INSTRUCTIONS FOR INSTALLING THE 323604 (FOR
VCL385 KSR SET) AND 323605 (FOR VCL386 OR
VCL387 ASR SET) MODIFICATION KITS TO UPDATE
MODEL 35 PRIVATE LINE SETS HAVING THE 305446
SIGNAL REGENERATOR

1.01 The 323604 and 323605 modification kits update the 305446 regenerator assembly supplied with the sets to provide signal regeneration.

FIGURE 1

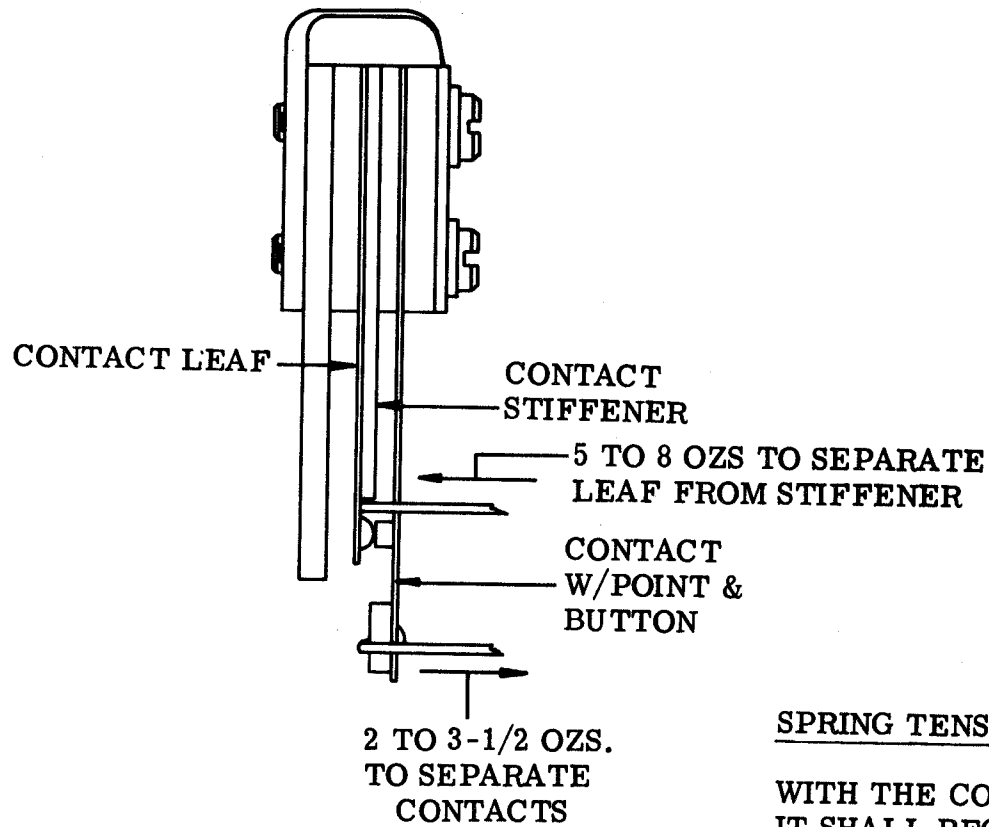
3. ADJUSTMENTS AND LUBRICATION - There are no adjustments or lubrication for the kits other than that the 319946 contact assembly of the 323604 kit must be checked and adjusted, if necessary, as given on Figure 1. The 321916 contact assembly of the 323605 kit must be checked and adjusted, if necessary, as given on Figure 2.

SPRING TENSION REQUIREMENTS

WITH THE CONTACT POINTS SEPARATED IT SHALL REQUIRE 5 TO 8 OZS. TO SEPARATE THE CONTACT LEAF FROM THE CONTACT STIFFENER. WITH THE CONTACT POINTS CLOSED, IT SHALL REQUIRE 2 TO 3-1/2 OZS. TO SEPARATE THE CONTACT POINTS.

FIGURE 3

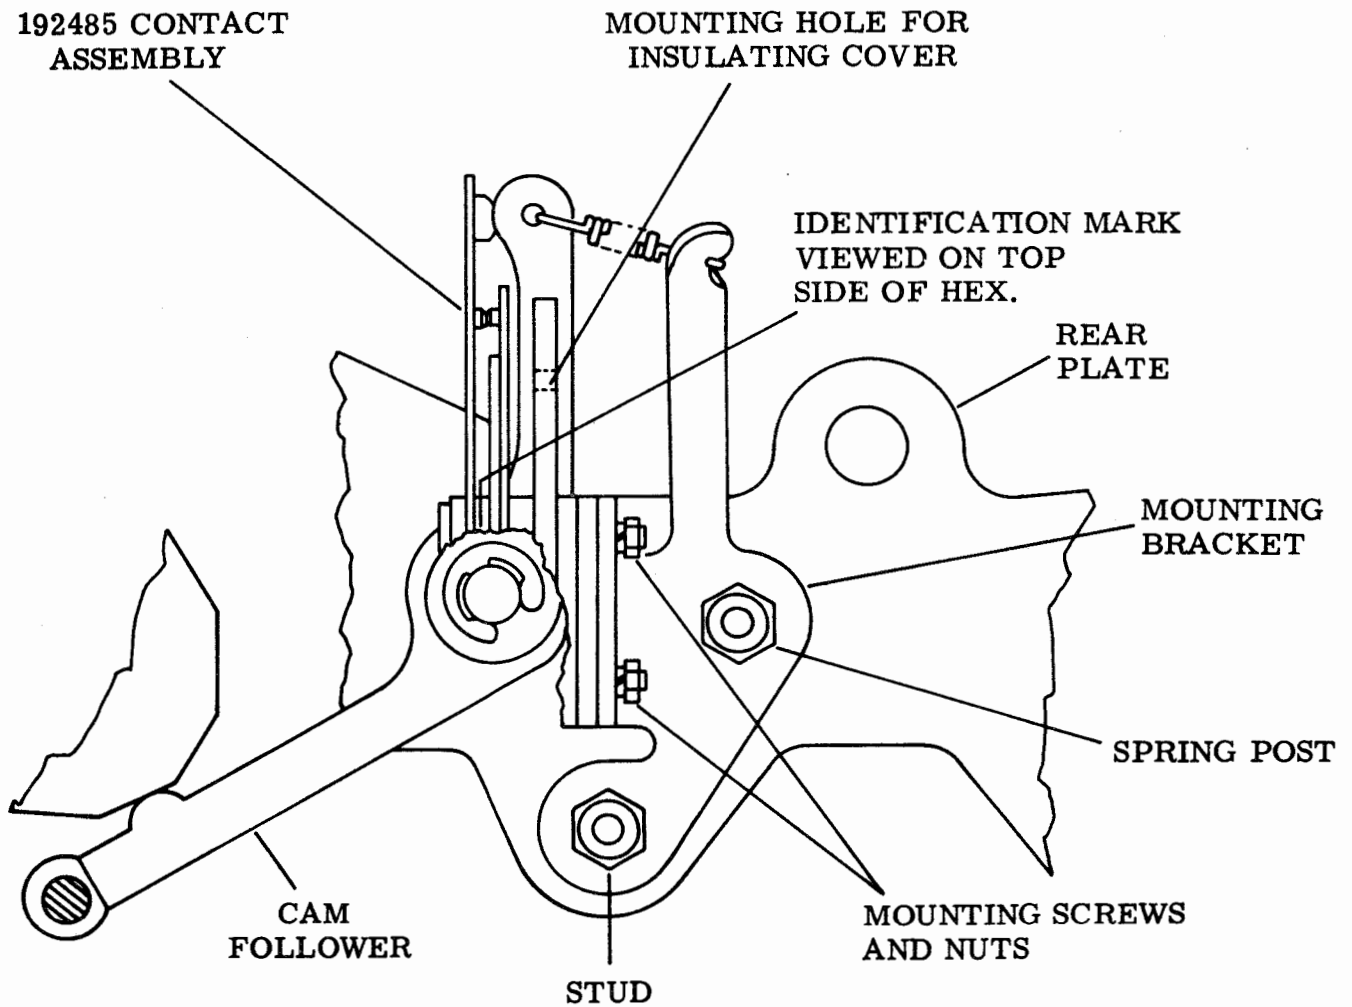
- (1) Isolate the set from all power sources.
 - (2) Remove and retain the 195053 insulating cover from the 192485 contact assembly by loosening its mounting screw. (See Figure 3.)

- (4) Remove the 192485 contact assembly from the keyboard by loosening the two nuts on the mounting screws. (See Figure 3.)
 - (5) Remove the two locknuts, lockwashers and the clamp plate from the 192485 contact assembly mounting screws and install them on the new 319946 contact assembly mounting screws.

FIGURE 4

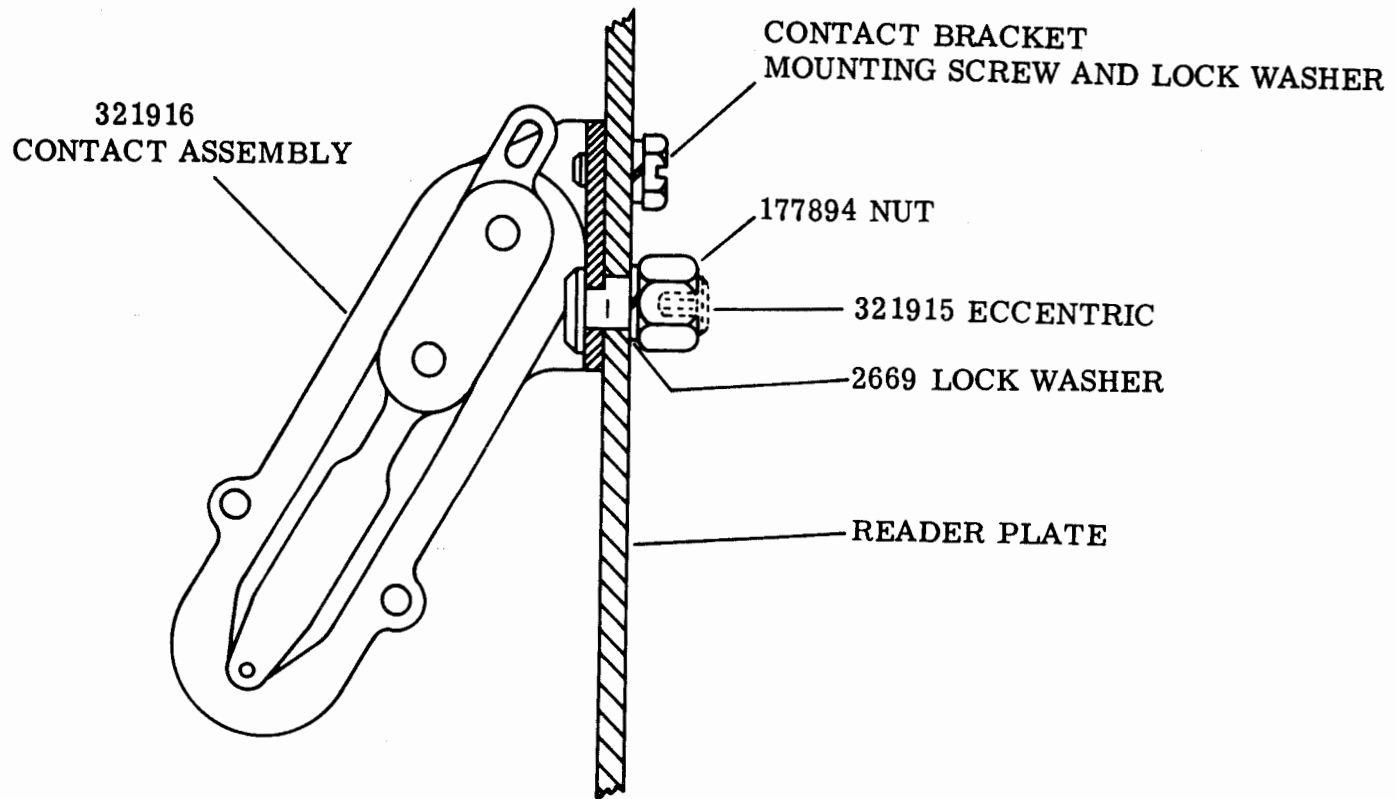
- (4) Install the contact assembly 321916 in the LXD with the hardware retained in Paragraph 2.03 (1) and the 321915 eccentric, 2669 lockwasher, and 177894 nut furnished with the modification kit. (See Figure 4.)

FIGURE 5

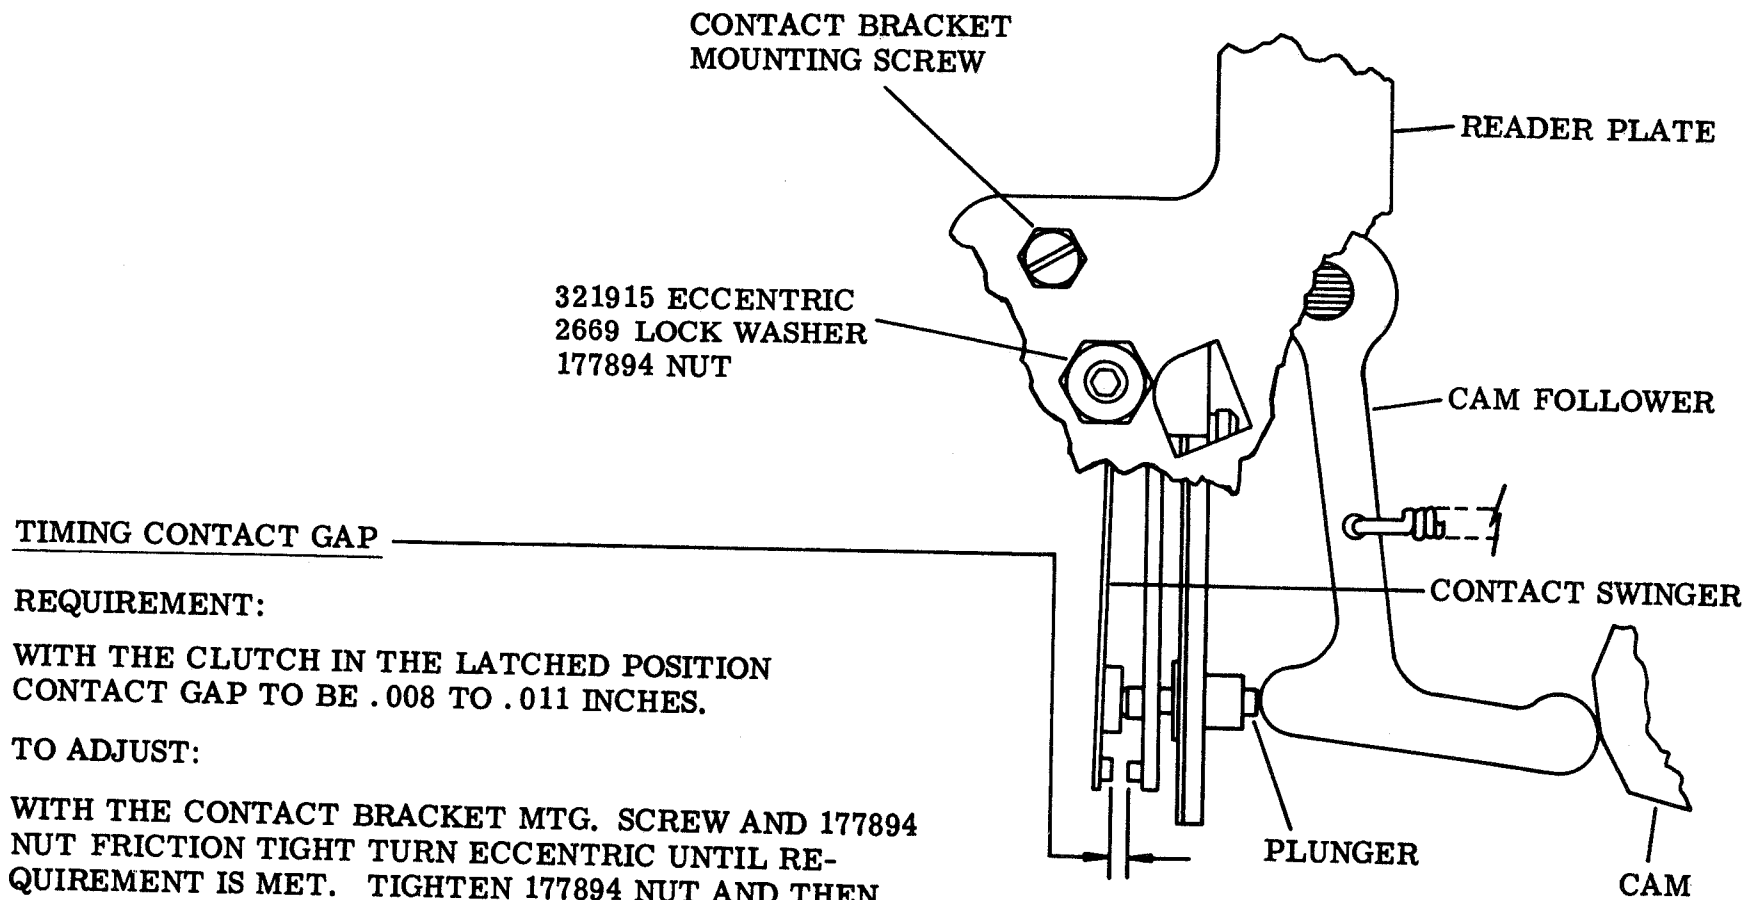
- (5) Adjust the 321916 timing contact assembly as specified in Figure 5. Replace the plastic cover.
- (6) If facilities are available for strobing the contact assemblies in the LXD, LK, and LAK then the contact gaps should be refined in accordance with requirements specified in Figure 6 (Teletype Bulletin 280B).

TIMING CONTACT GAP

REQUIREMENT:

WITH THE CLUTCH IN THE LATCHED POSITION
CONTACT GAP TO BE .008 TO .011 INCHES.

TO ADJUST:

WITH THE CONTACT BRACKET MTG. SCREW AND 177894
NUT FRICTION TIGHT TURN ECCENTRIC UNTIL RE-
QUIREMENT IS MET. TIGHTEN 177894 NUT AND THEN
THE BRACKET MTG. SCREW. RECHECK GAP AND REFINE
IF NECESSARY.

CHECK FOR PROPER ADJUSTMENT:

WITH CAM FOLLOWER ON LOW PART OF CAM AND CLEARANCE TAKEN
UP BETWEEN PLUNGER AND CAM FOLLOWER THERE MUST BE SOME
CLEARANCE BETWEEN PLUNGER AND CONTACT SWINGER.

Figure 6

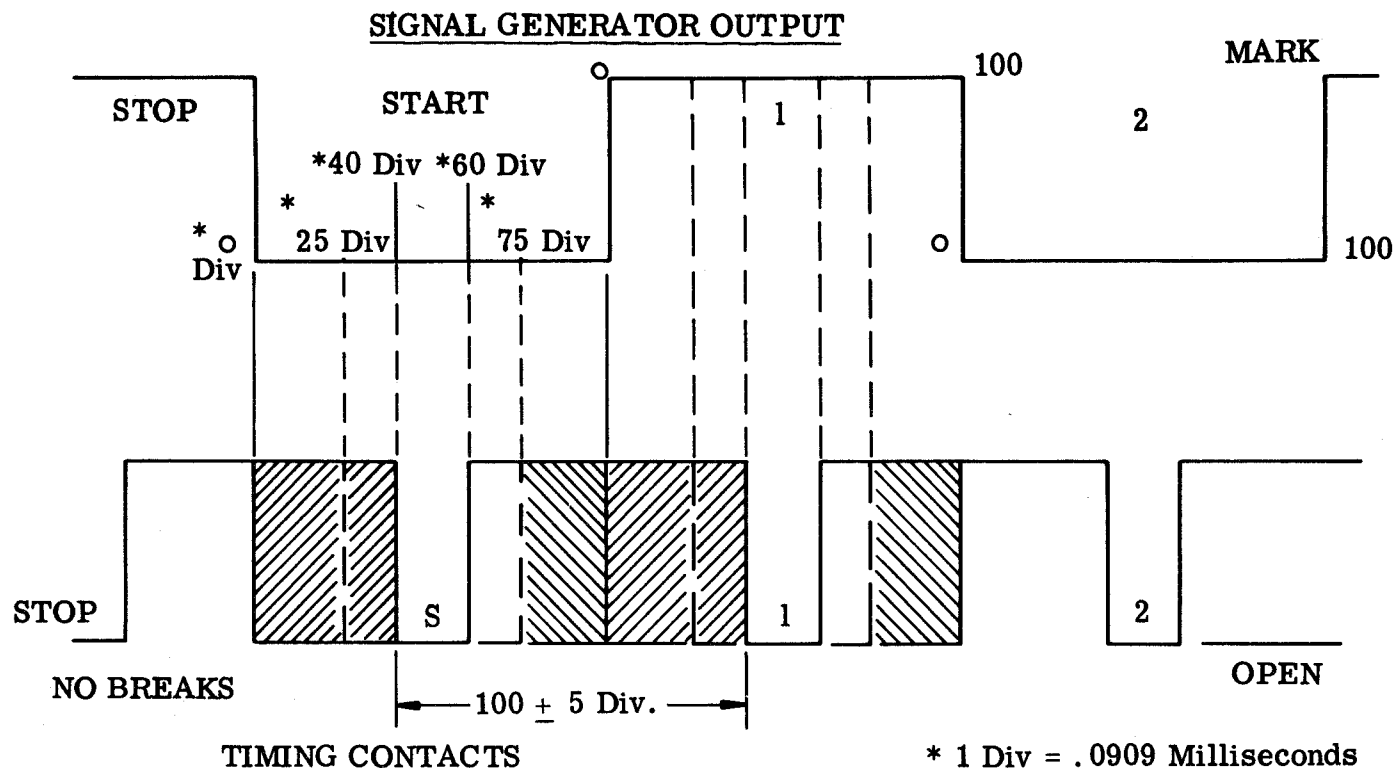
- (8) If strobe facilities are available refine gap as outlined in Figure 6.
 - (9) For signal generator contact replacement refer to Paragraph 2.04.
- 2.03 The 192605 contact assembly in the Transmitter Distributor (LXD) must be replaced by a 321916 contact assembly. (Kit 323605 -VCL386 and VCL387 ASR only.)

Timing Contacts Operating Requirements With Stroboscope:

- a. With the signal generator and stroboscope set up in accordance with the standardized information (customers other than Bell refer to Teletype Bulletin 280B), the light image of the timing contacts shall meet the following requirements for speeds up to and including 100 WPM.
 - (1) Open for a minimum of 20 divisions between the 25 div. and 75 div. points of each 100 div. pulse.
 - (2) The close to open transitions shall be in multiple of 100 div. \pm 5 div. from the close to open transition of the start pulse.
 - (3) There shall be no contact break between the 0 div. point and the close to open transition point and no contact break between the 75 div. point and 100 div. point of each pulse. There shall be no contact make between the 175 div. point and the 200 div. point of the stop pulse.
